Minimum TX OMA Launch Window

Ali Ghiasi

IEEE 802.3cu Task Force

May 23, 2019

Proposed 100G-FR/LR Allowed TX OMA Launch Window

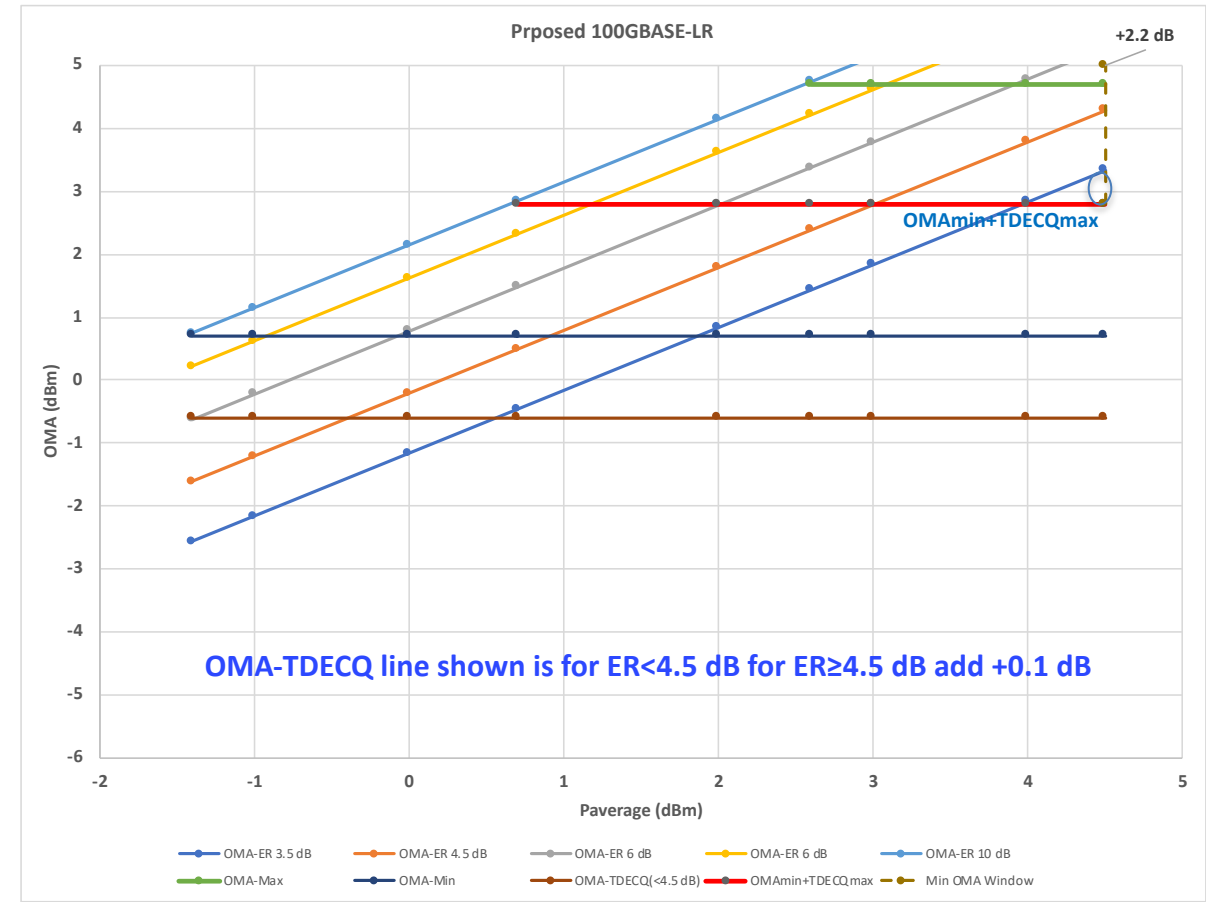
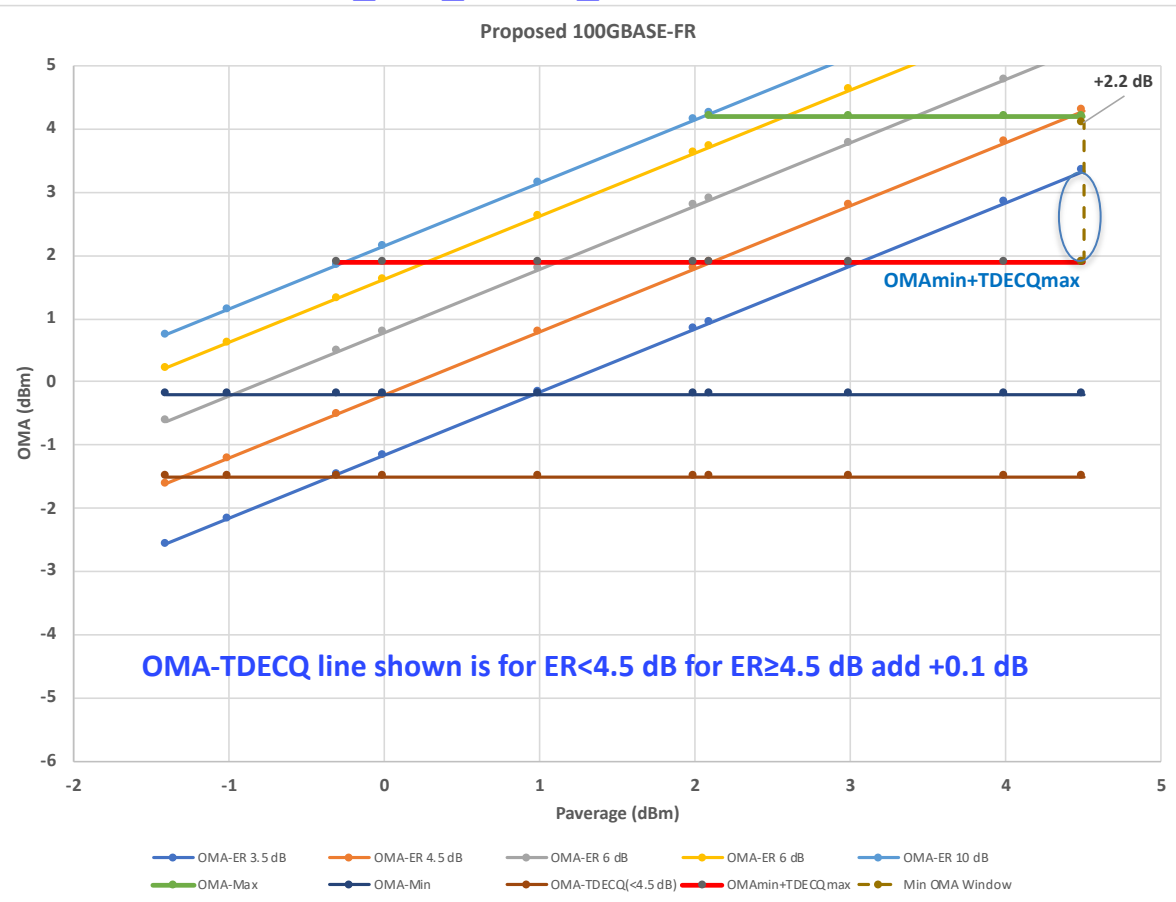
Depending on ER 100G-FR provides 1.4-2.3 dB and 100G-LR 0.5-1.9 dB fails min TX OMA window of 2.2 dB!

400G-FR4/LR4 Allowed TX OMA Launch Window

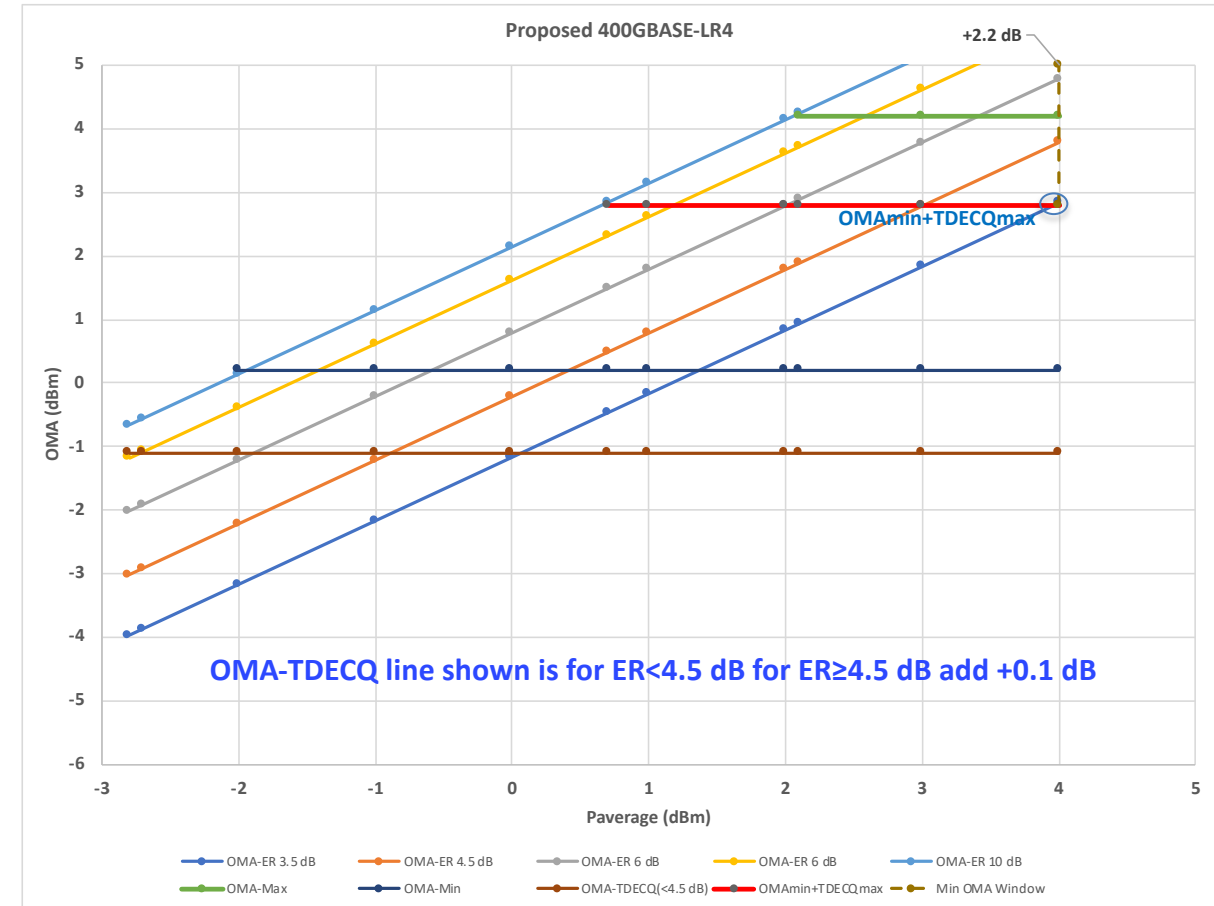
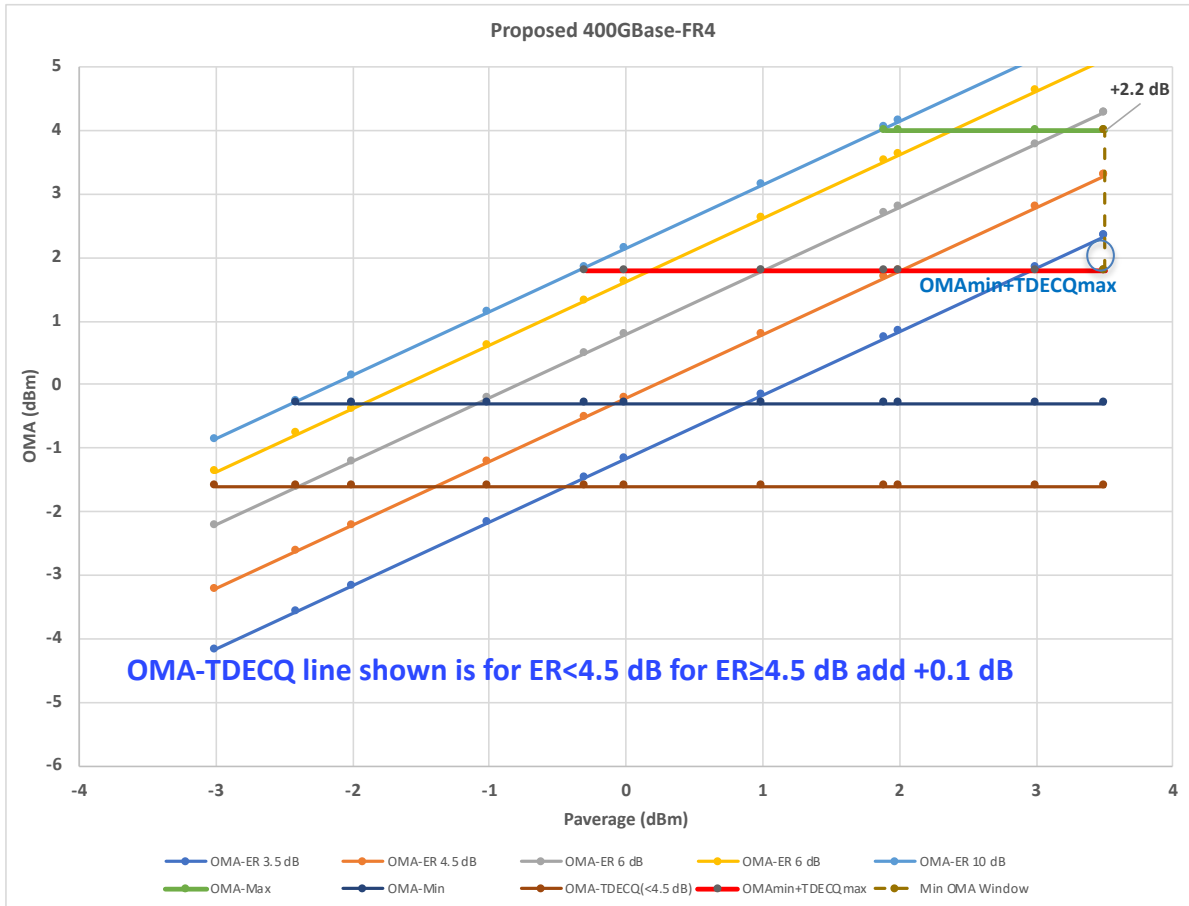
At Min ER 400G-FR4 provides **0.5-2.2 dB** and 400G-LR4 **0-1.4 dB** fails min TX OMA window of 2.2 dB!
